Denitex Ltd (Extension)

27 January 2025

Observation-1: Mismatches in as-built drawings. (ETP Building)

Beam layout

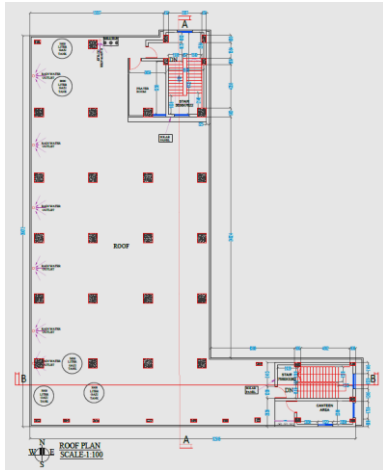
Beam is not aligned with the column line

Description: At the first-floor level beam was found not aligned with the column grid.

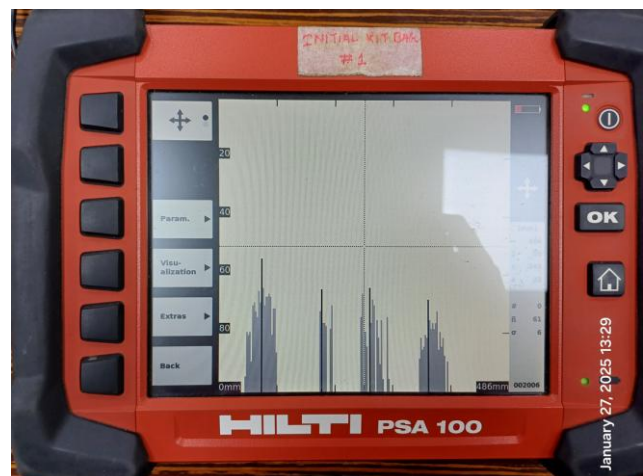
Description: Rebar at C-2 type column not matched with drawings. The number of rebars found was 12 instead of 16. The building engineer is required to confirm the amount of rebar in the column and update the drawing.
